Service Bulletin

Bulletin No.: PI1255

Subject: Changing Outside Rearview Mirrors

Models: 2014 Chevrolet Silverado 1500
2015 Chevrolet Silverado
2014 GMC Sierra 1500
2015 GMC Sierra
Equipped with RPOs DL3, DL8, DE2

3802187

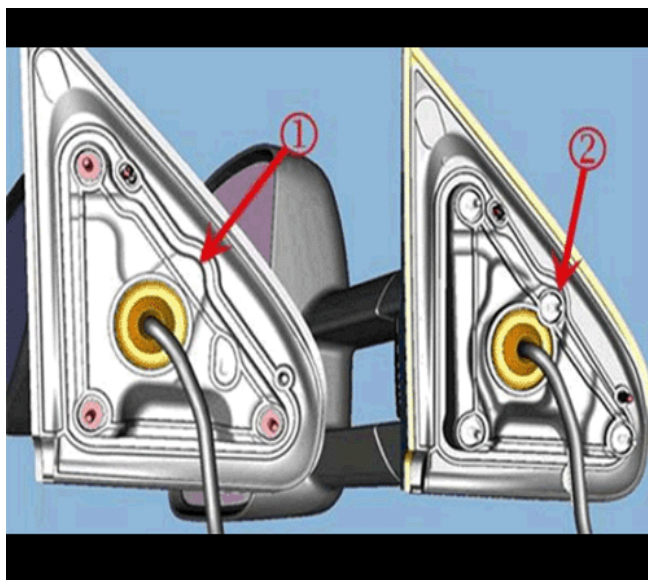
Note: If upgrading from DE2 (Mirrors, outside manual, Black) to DF2 (Mirrors, outside high-visibility vertical camper-style, Black with manual folding and extension and lower convex spotter glass) will only require drilling of the fourth hole (2). See the picture below.

When swapping to the trailer tow mirrors, the first thing to know is the installation of the trailer tow mirrors may require the technician to add an additional mounting hole to the door (See the chart below). Non-trailing mirrors only require 3 mounting holes. Trailer tow mirrors require 4 mounting holes.
